SUBJECT: AMENDMENT NO.126 TO FACILITY OPERATING LICENSE NO. DPR-50

THREE MILE ISLAND NUCLEAR STATION, UNIT NO. 1

AMENDMENT TO FACILITY OPERATING LICENSE

Amendment No. 126
License No. DPR-50

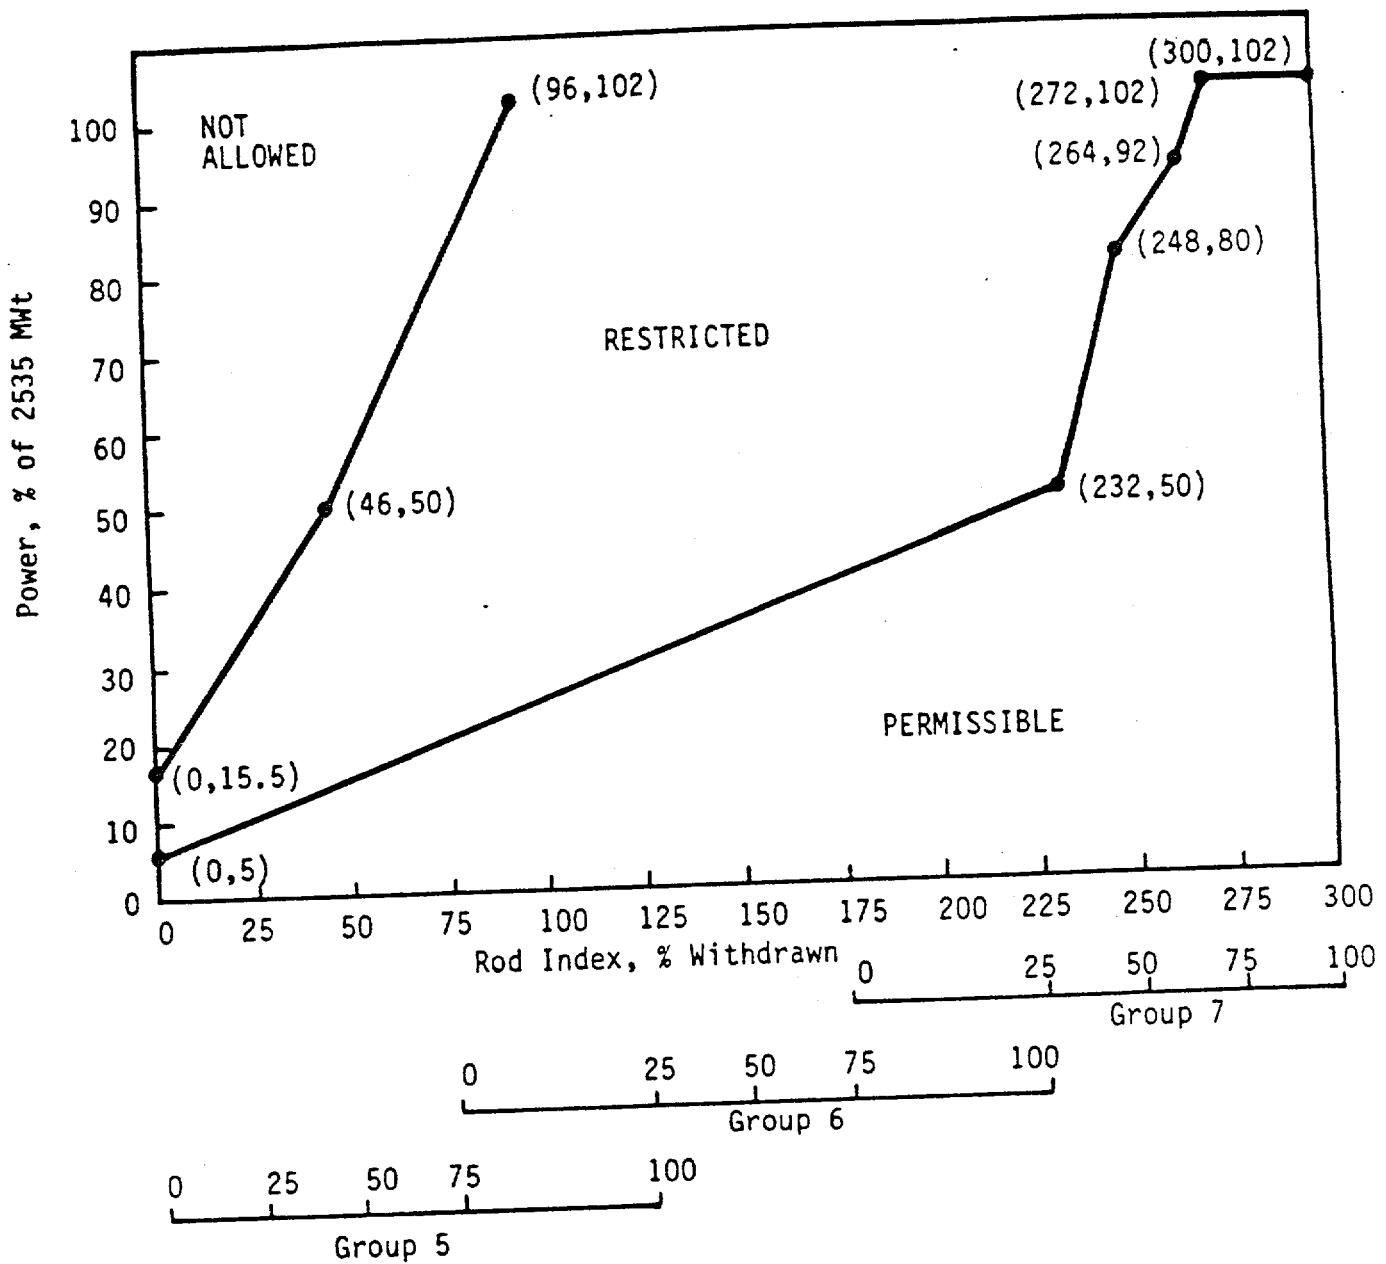
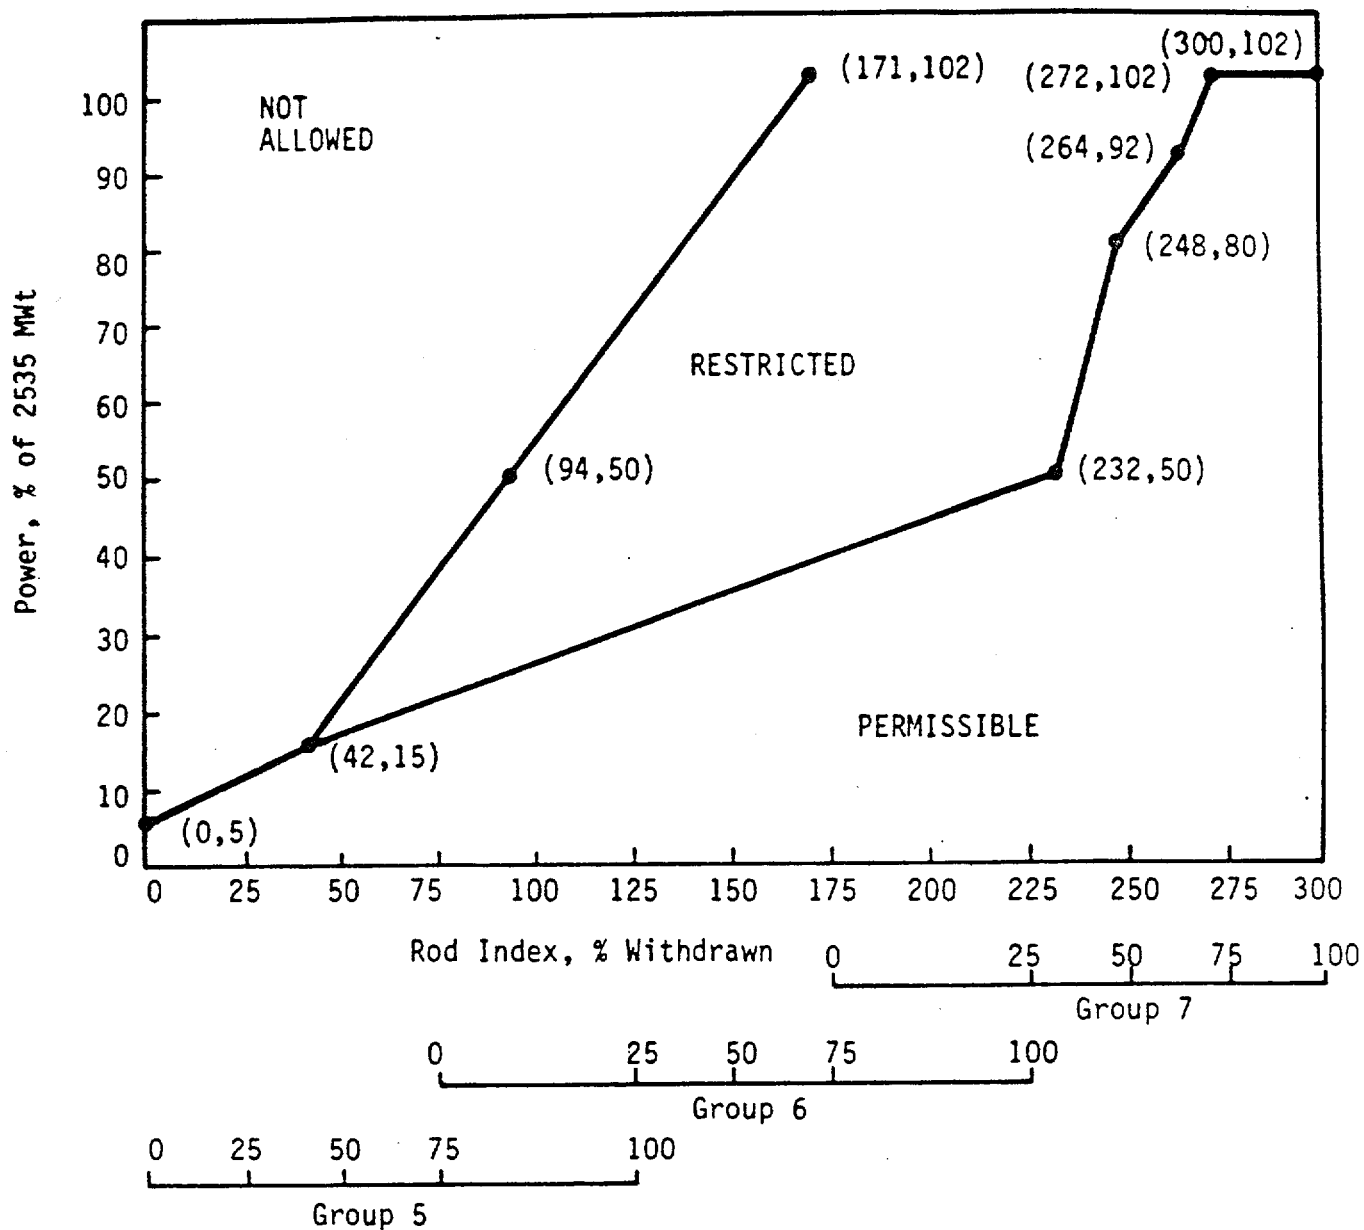
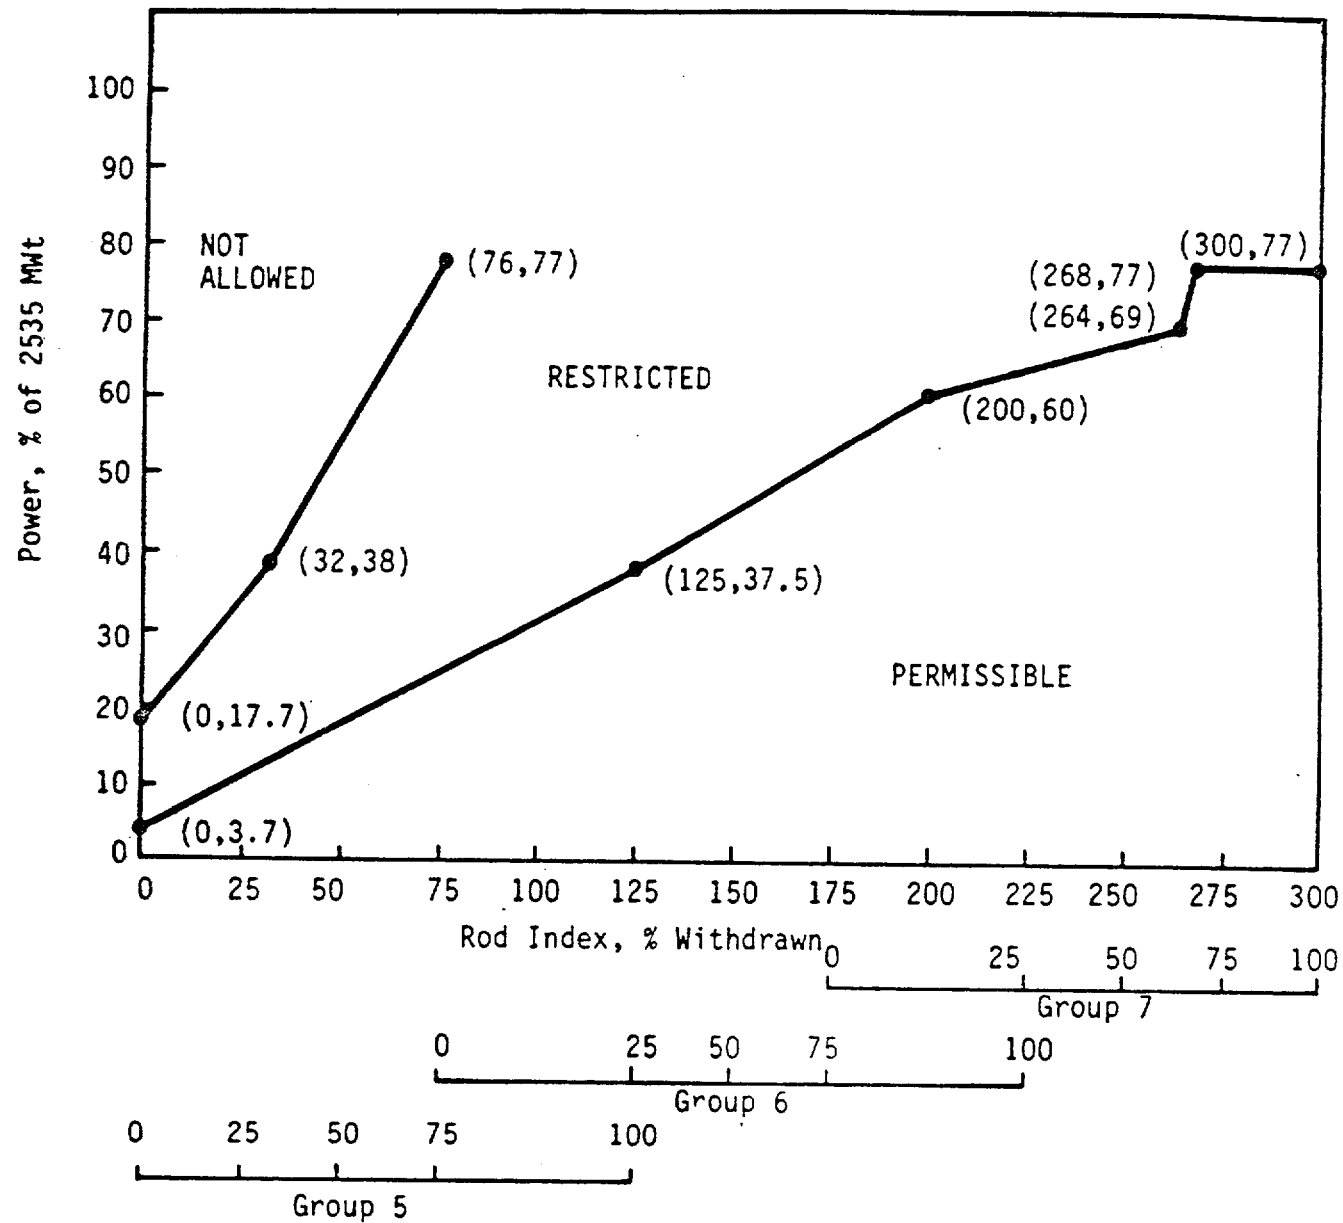
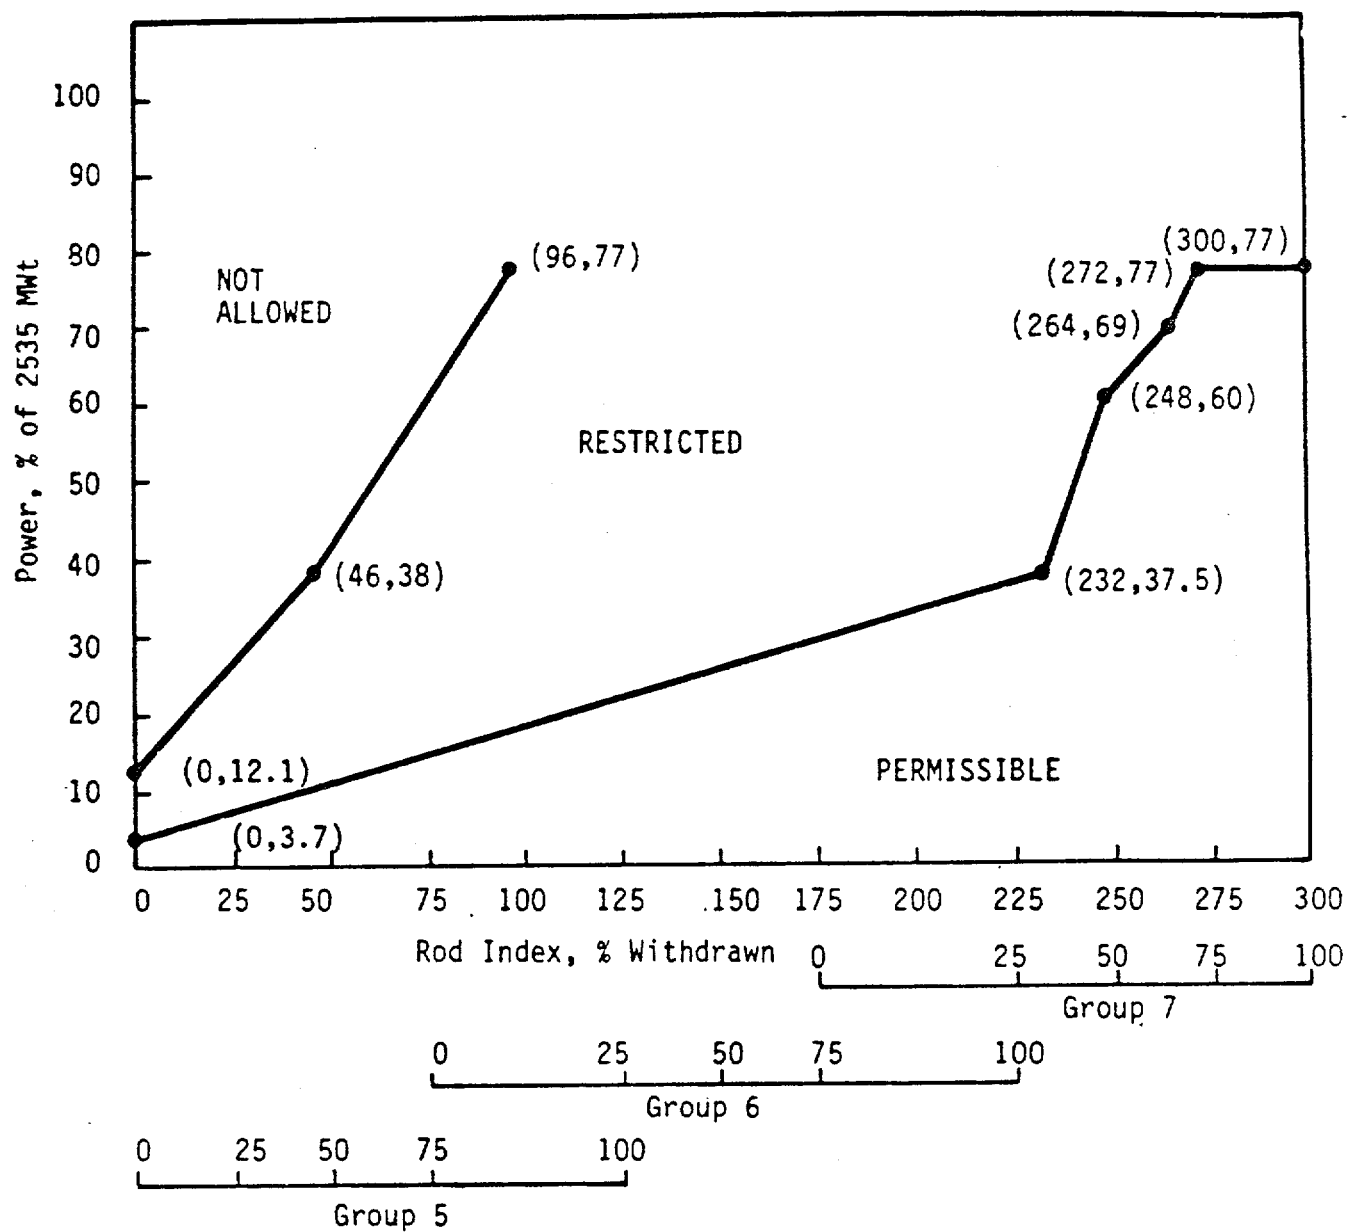
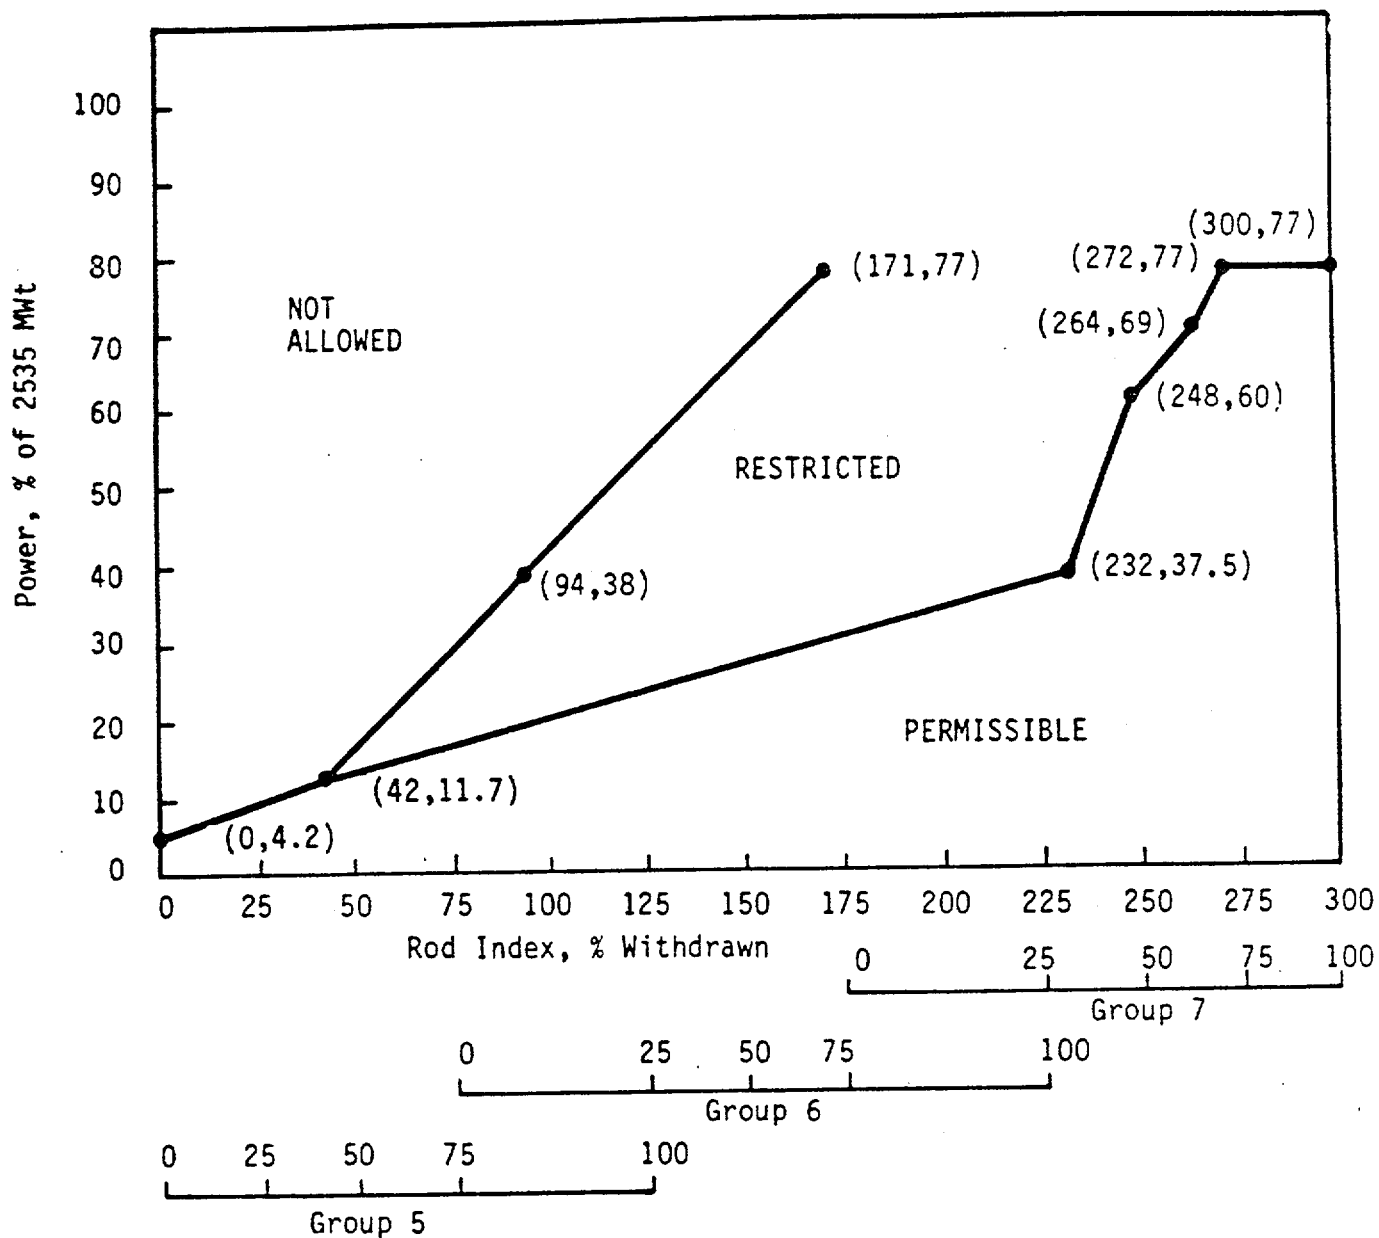
New control rod insertion limits (Figure 3.5-2A through Figure 3.5-2I) are provided for 4, 3 and 2 pump operation, as well as a function of burnup interval. These Figures are acceptable since they are based on the Cycle 6 safety analysis discussed previously.
